Application for Modification of Space  
 Station License (AMSC-1)

Amendment to Pending Application to  
 Launch and Operate a Next-Generation  
 Replacement MSS Satellite System

**OPPOSITION OF INMARSAT VENTURES LTD**

March 25, 2004

Figure IV.A-1 - Uplink Interference Mechanisms

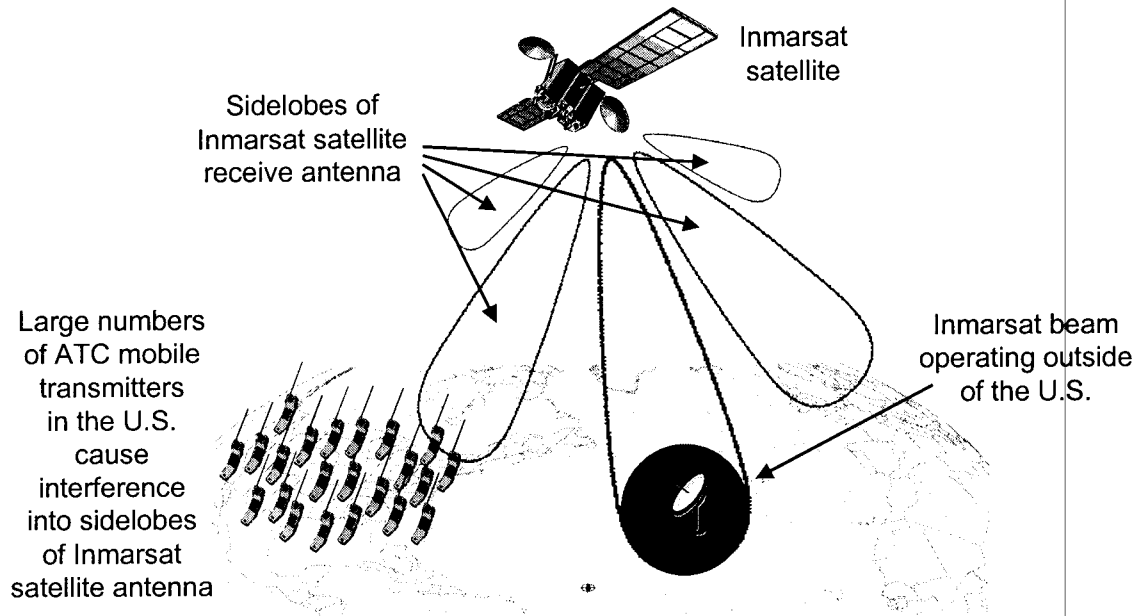
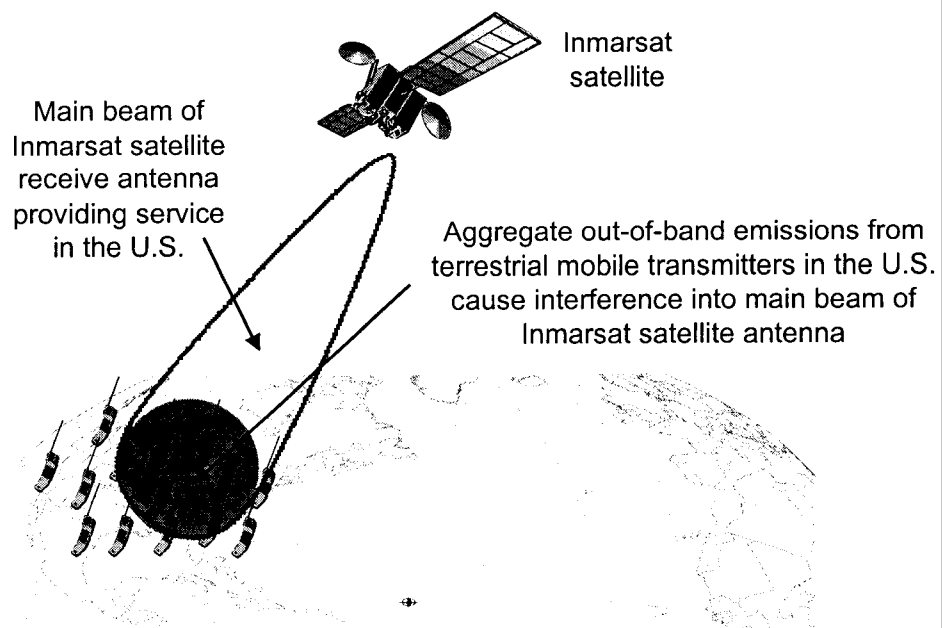
MSV's proposed ATC system will cause uplink interference into Inmarsat's satellite in two ways. Interference will occur via the sidelobes of the Inmarsat satellite antennas in the case of the co-frequency channels used by Inmarsat outside of the USA (termed "co-channel" uplink interference herein), and via the main beam of the Inmarsat satellite antennas in the case of the adjacent frequency channels used by Inmarsat within the USA (referred to as "adjacent channel" uplink interference herein). These two interference paths are shown diagrammatically in Figure IV.A-1 below.

Figure IV.B-1 - Downlink Interference Mechanism

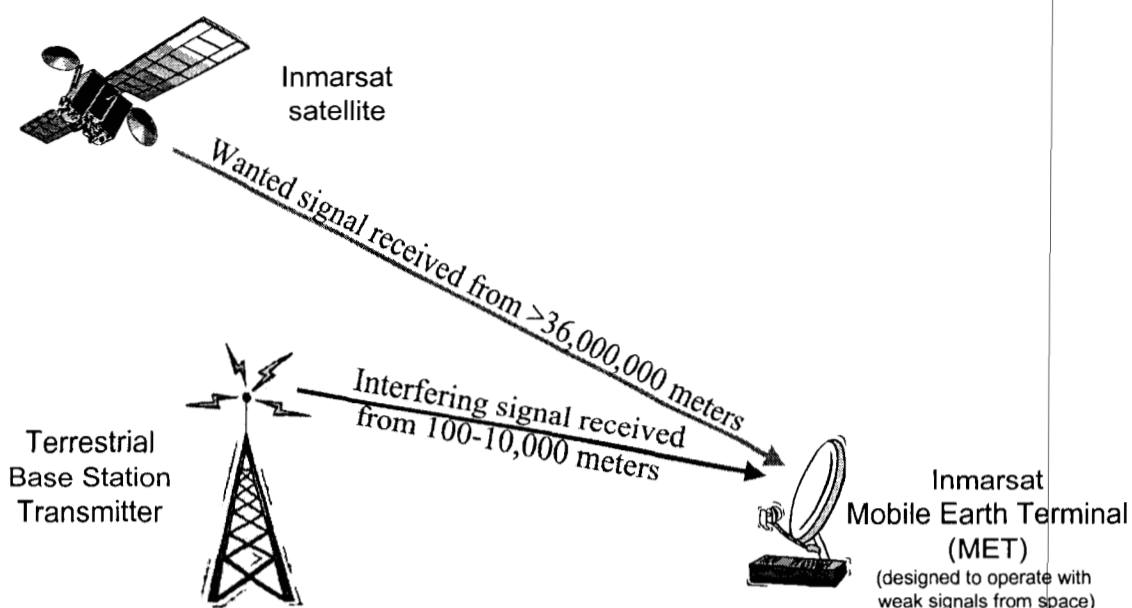
All parties recognize that MSV's proposed ATC base stations will cause downlink interference into Inmarsat's METs. The problem is created by the fact that the ATC base stations are much closer to the Inmarsat METs than is the intended Inmarsat satellite, as shown in Figure IV.B-1 below.

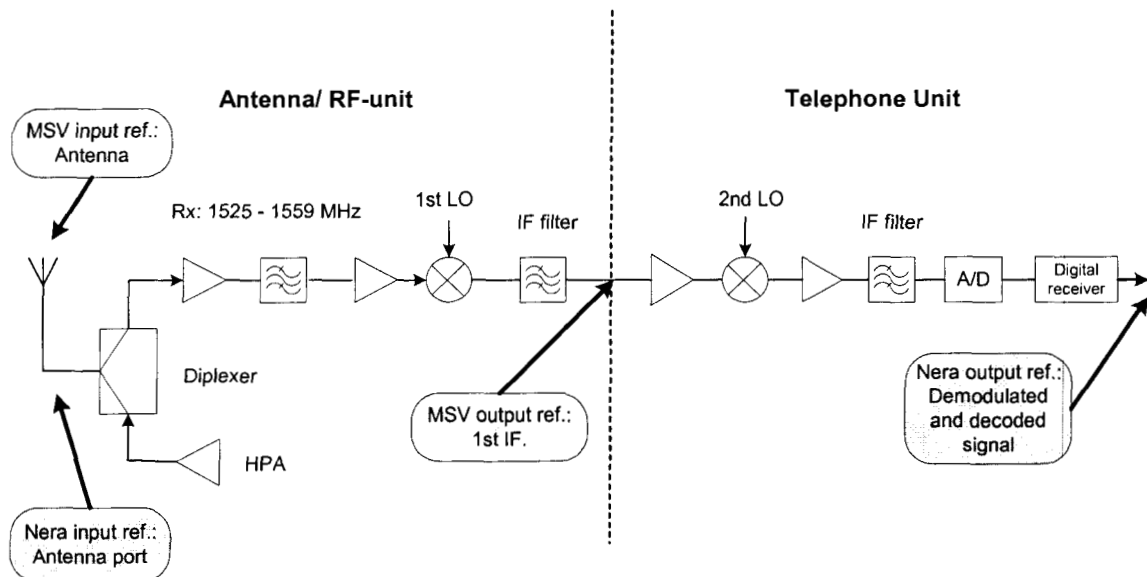
MSV's test method is based on measuring the 1 dB compression point between the input and output of the NERA mini-M Worldphone Antenna/RF unit by applying a single high-powered signal and measuring the output at an intermediate frequency (IF). This method is invalid because it:

- ignores the effect an interfering signal will have on the demodulation of a wanted signal;
- ignores the generation of harmonic signals and the resulting intermodulation effects created by non-linearities when applying more than just one signal at the receiver input;
- ignores the degradation effects that will be suffered by the elements that are further down the receiver chain such as A/D converter, amplifiers, downconverters and filters; and

The shortcoming of MSV's test method becomes apparent when considering NERA's actual mini-M receiver architecture (see Figure below) which is separated into an Antenna/RF unit and a Telephony (or modem) unit with an IF-interface in between.

As can be seen from the figure, there are a number of important and sensitive receiver elements after the IF which MSV has not taken into account. All the receiver elements to the right of the dotted vertical line are effectively left untested by MSV's test method.

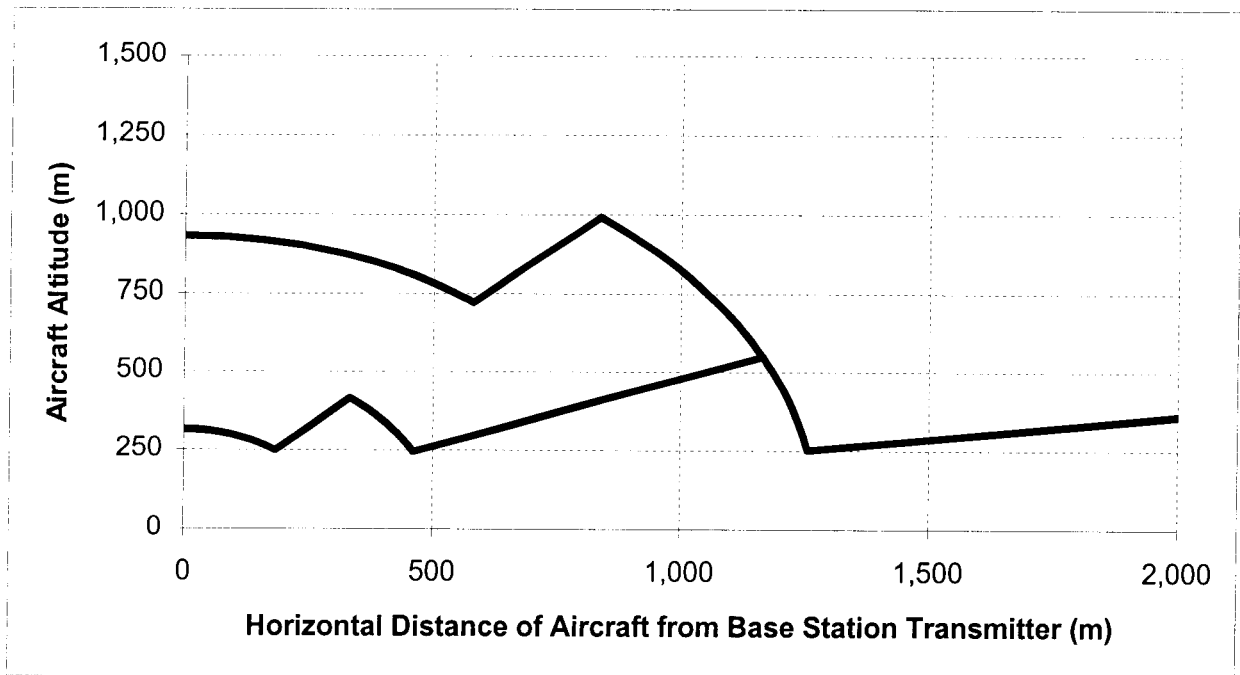
As usual, MSV has attempted to mask the impact of its proposed antenna change by a complex statistical approach. However, the facts are simple. The MSV proposal to relax the overhead gain suppression will impact the safety of an aircraft using an Inmarsat receiver at the most critical times – just before landing and just after taking off. This is because the aircraft is most likely to be overhead, or nearly overhead, relative to an ATC base station, and at a low altitude, at this point in its flight.

The effect of the proposed MSV relaxation in the overhead gain suppression of its base station antenna is shown in the following diagram, where the onset of overload in the Inmarsat receiver is shown as a function of the horizontal and vertical distances between the aircraft and the ATC base station.<sup>149</sup>
